NORTH ANNA POWER STATION

Unit 2 CTS
Mark-Ups

VOLUME 3

Improved Technical Specifications

Figure 2.1-1 REACTOR CORE SAFETY LIMITS FOR THREE LOOP OPERATION

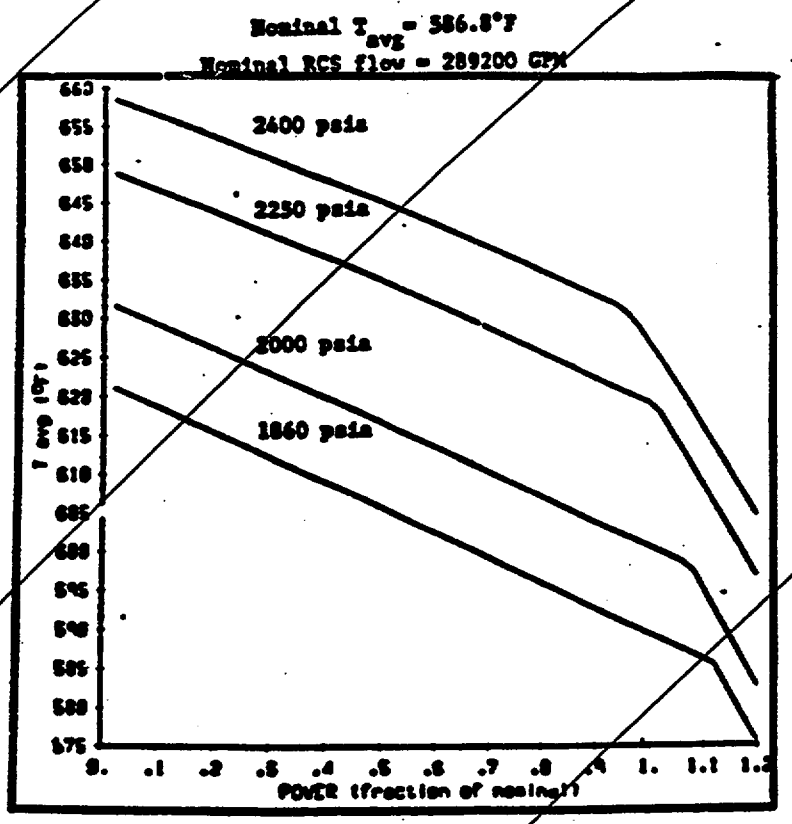
LA.1

FIGURE 3.4-1

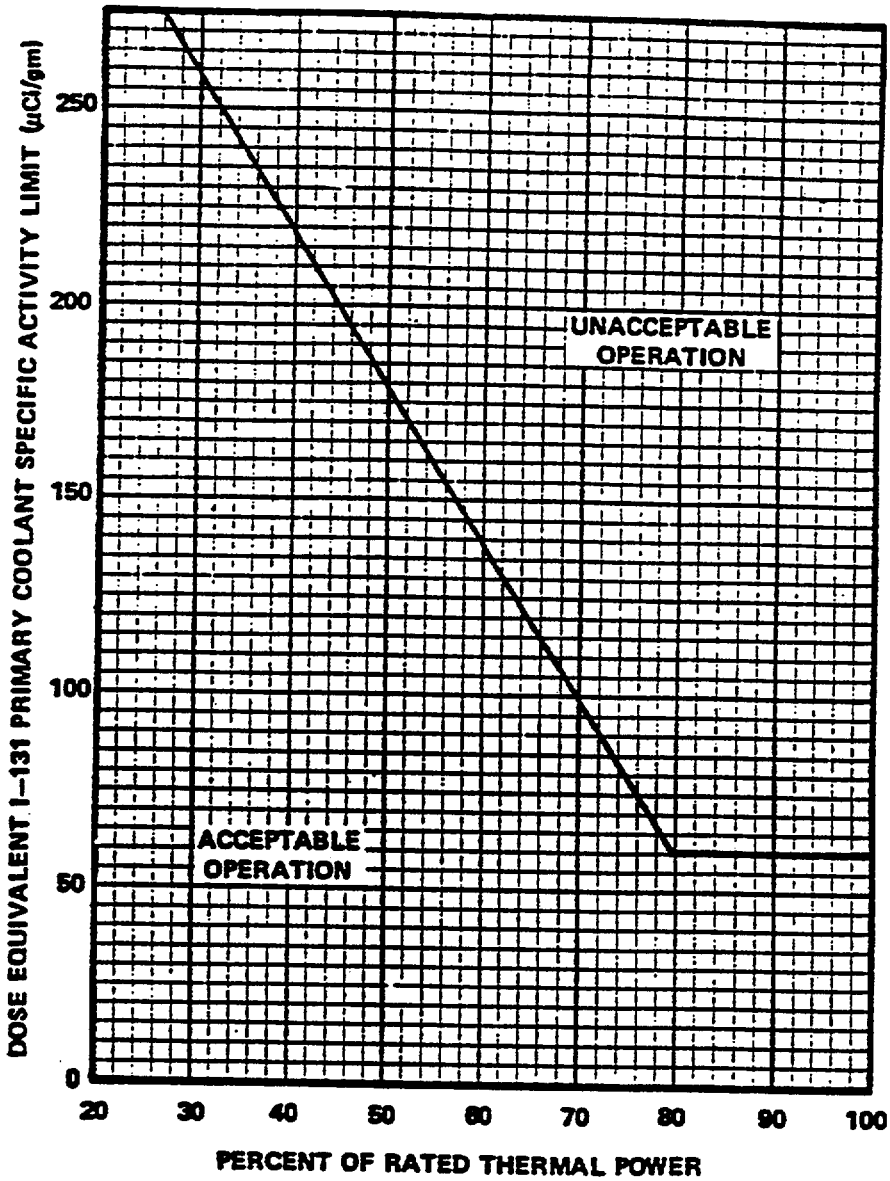
Figure 3.4.16-1

Figure 3.4-2 — **North Anna Unit 2**
Reactor Coolant System Heatup Limitations

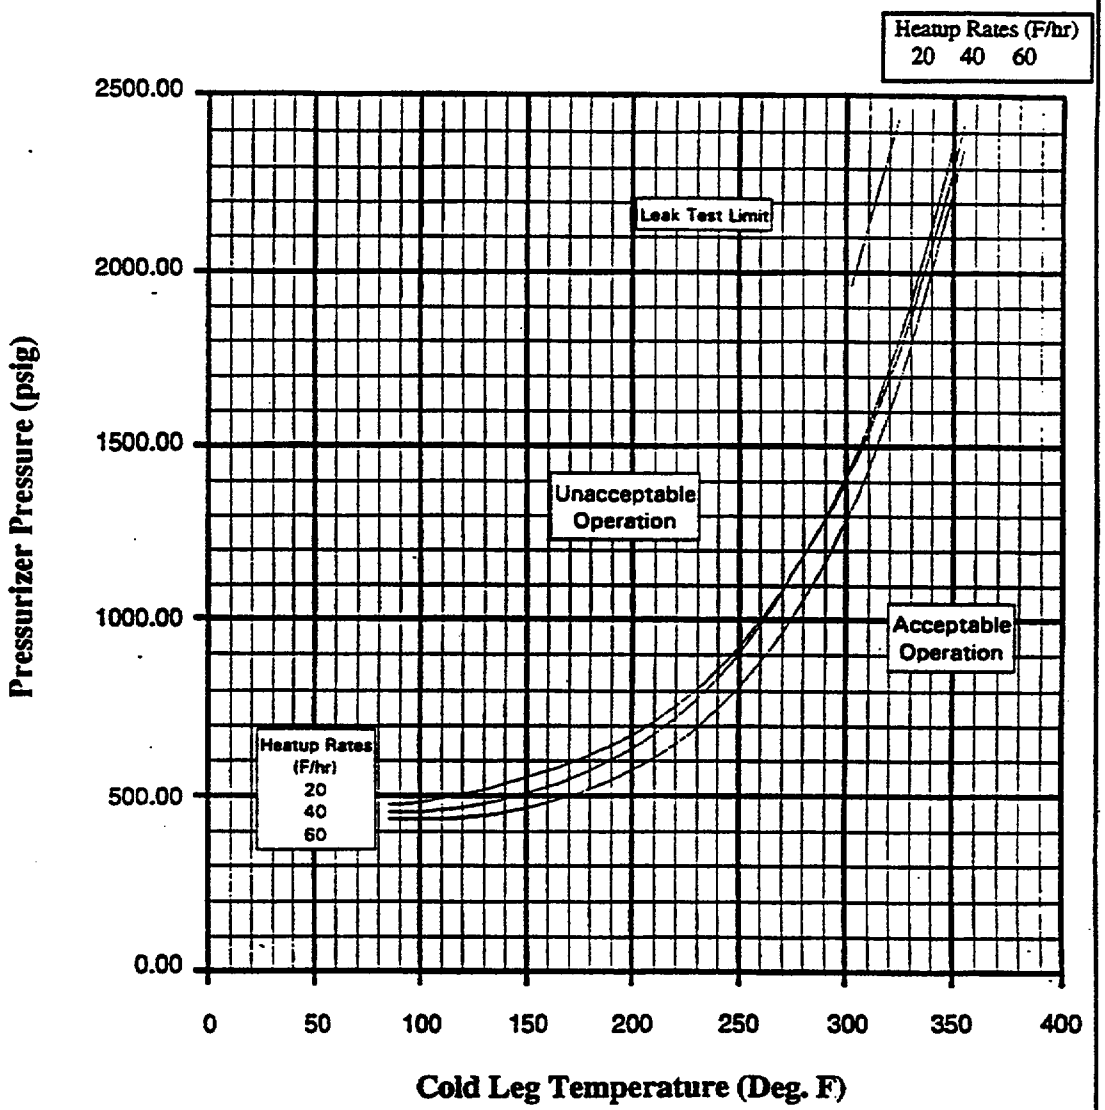
Figure 3.4.3-3

Figure 3.4-3 — **North Anna Unit 2**
Reactor Coolant System Cooldown Limitations

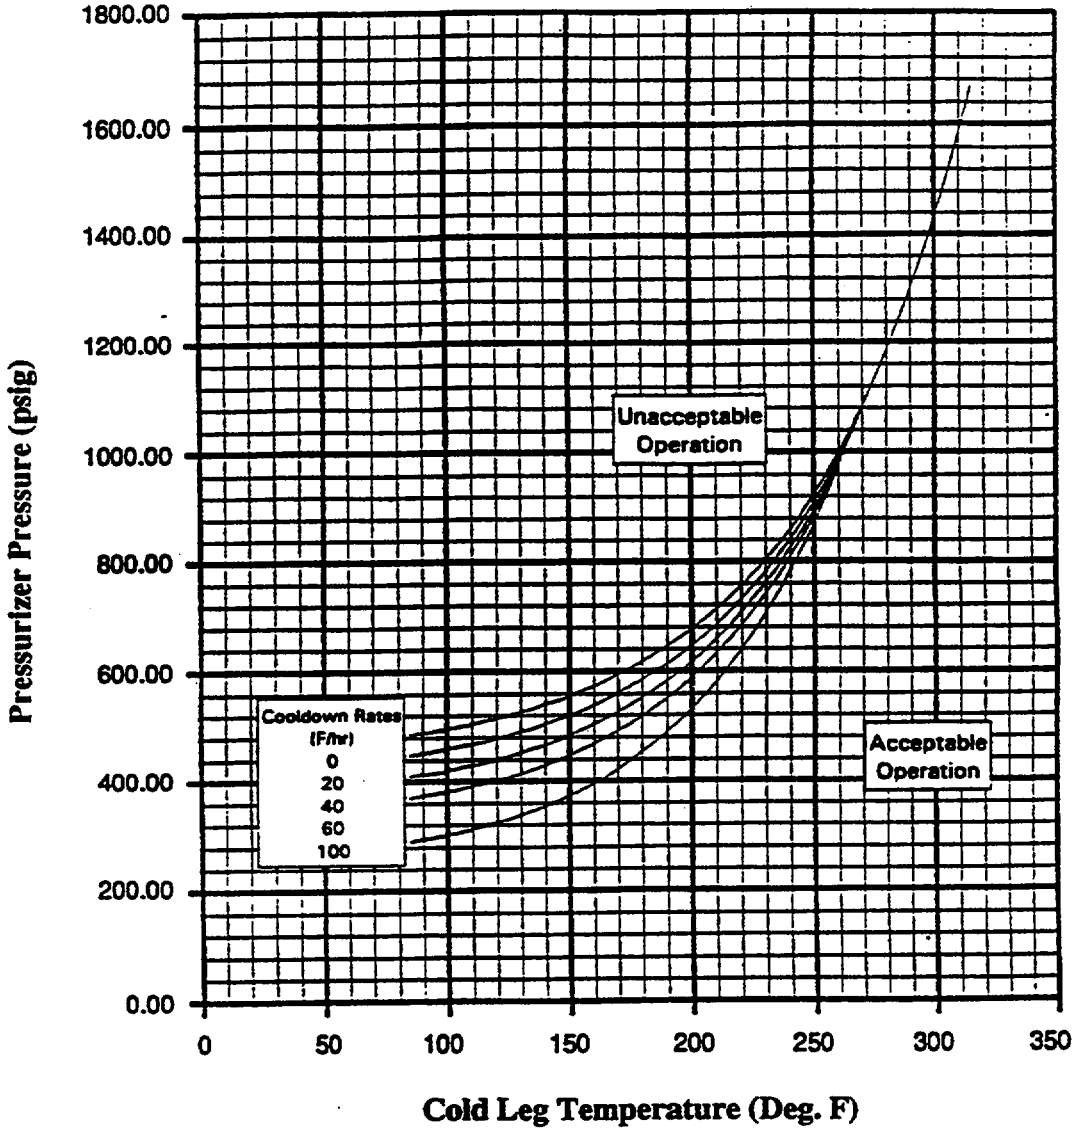
Figure 3.4.3-4

Figure 3.6-1

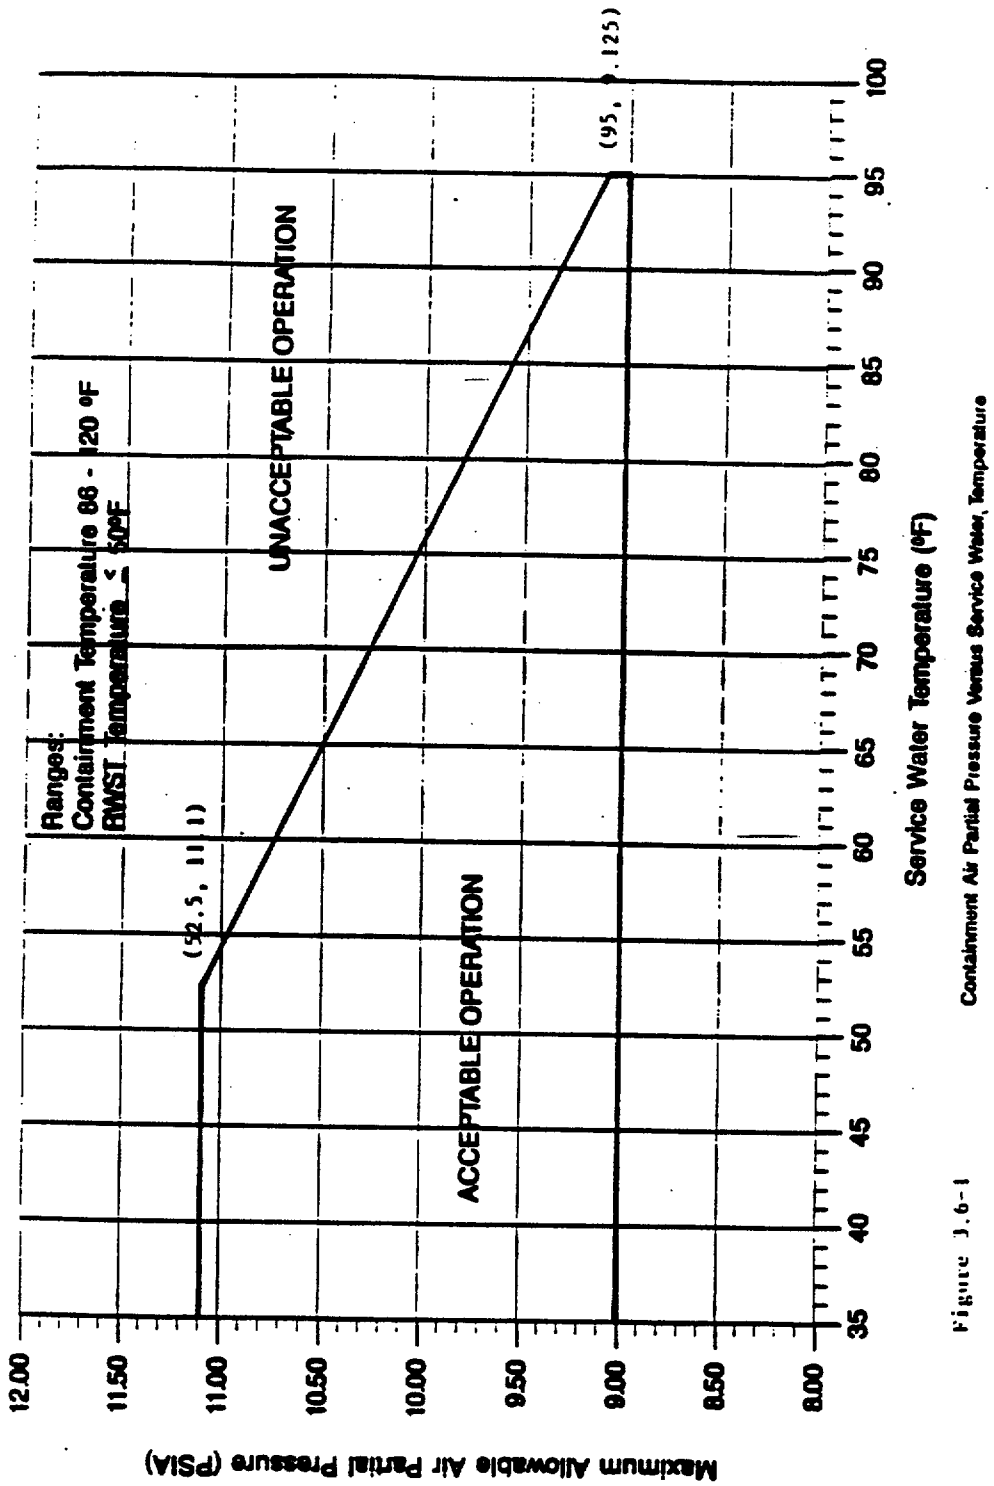
Figure 3.6.4-1

Figure 5.1.1

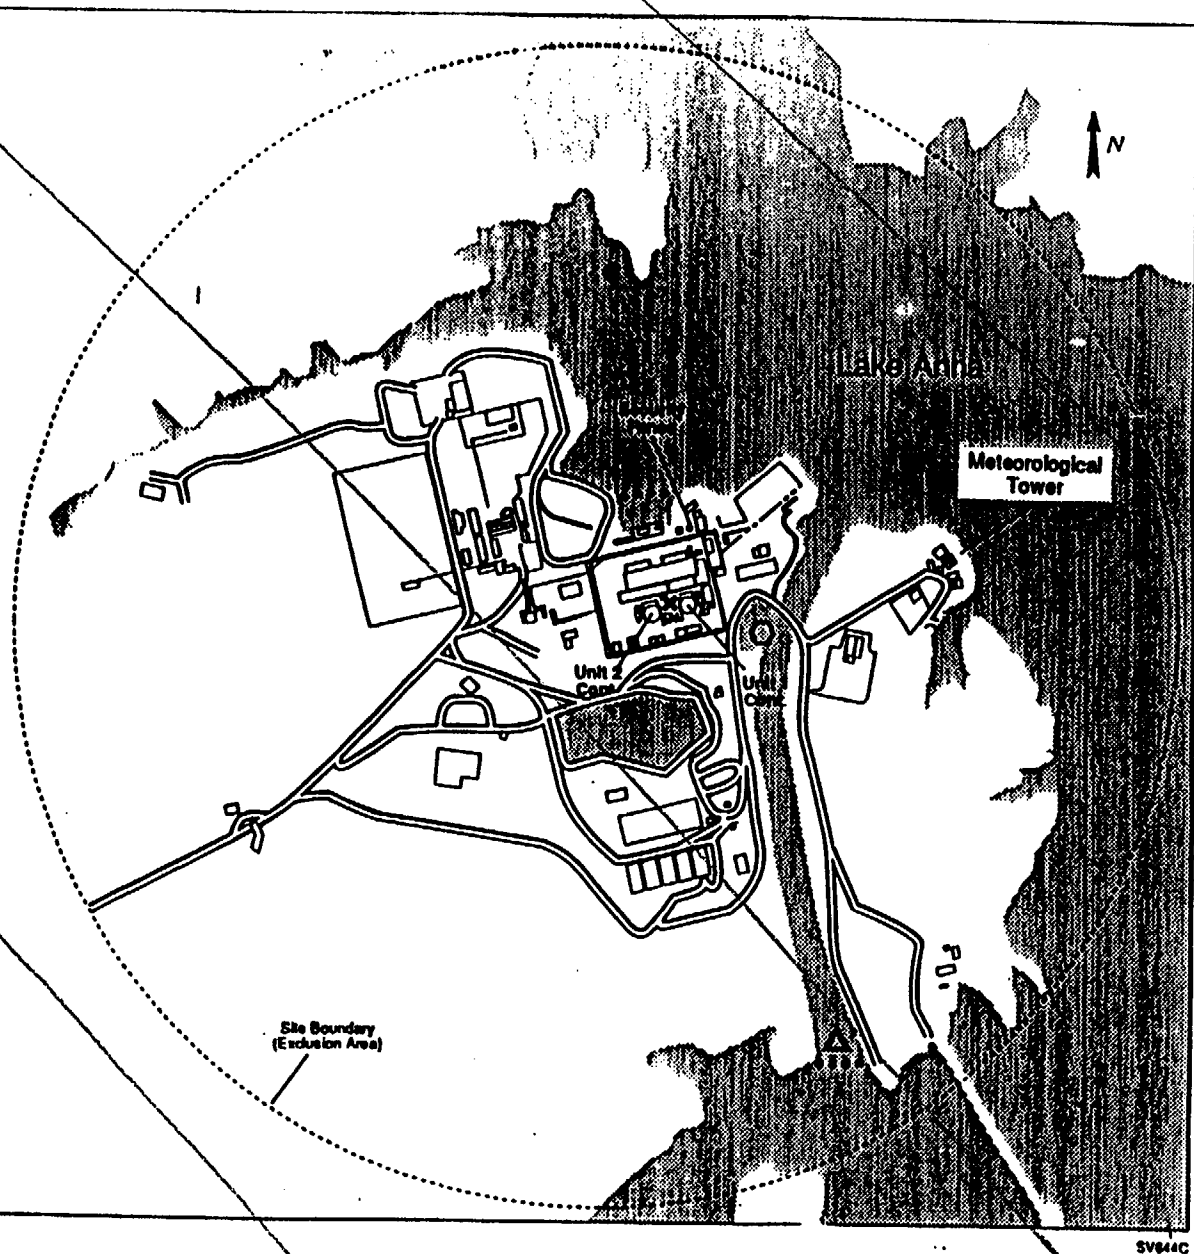
~~5.5.1 The meteorological tower shall be located as shown on Figure 5.1-1.~~ LA.6
